CCO #15-007

Project: 0483-01 - Perris High School No. 4
32255 Leon Road
Winchester, California 92596

Change Order #15-007: CE #020 - CCD #010 Louver Revision to B1 Lunch Shelter (Part 2 of 2)

CCD #010 Proposed Louver Detail Revision

LUNCH SHELTER PARTIAN SECT.

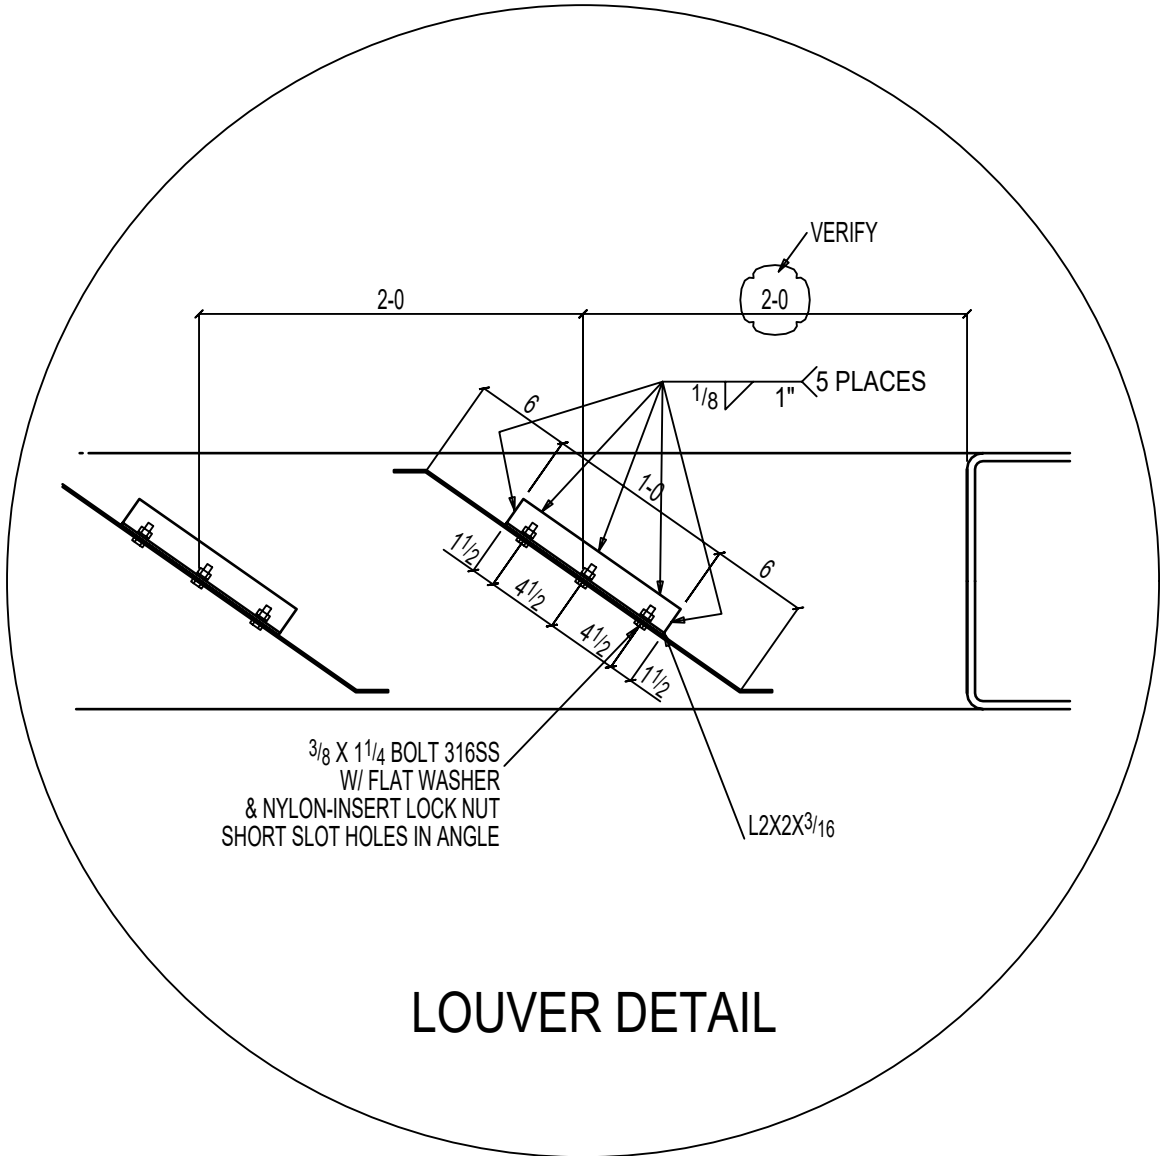
Please see the attached details for the louver attachment at the Lunch Shelter. There is a concern with the end spacing for the louvers. Please have the Architect verify the spacing in the detail that I have included.

-The proposed attachment detail is acceptable for the louvers.

-Spacing of louver start location is acceptable at 2'-0" per provided sketch.

LUNCH SHELTER LOUVER SECTION

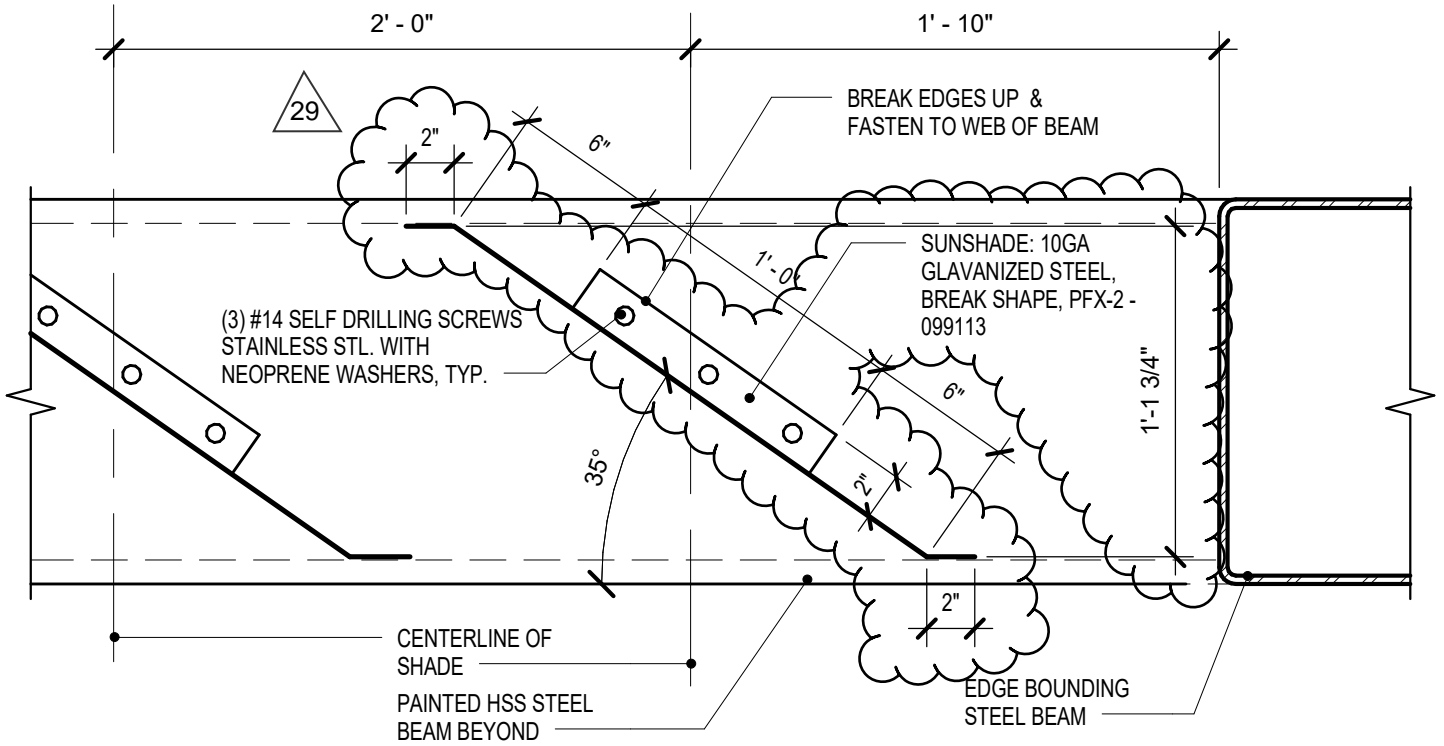
Brief description of construction change (attach additional sheets if needed):
[Louvers revision to Lunch Shelter on Building B1.](#)

CHANGE: ADDITIONAL HSS MEMBER ADDED AT LUNCH SHELTER.
REASON: REDUCE SPAN FOR LOUVERS.
REQUESTED BY: ARCHITECT
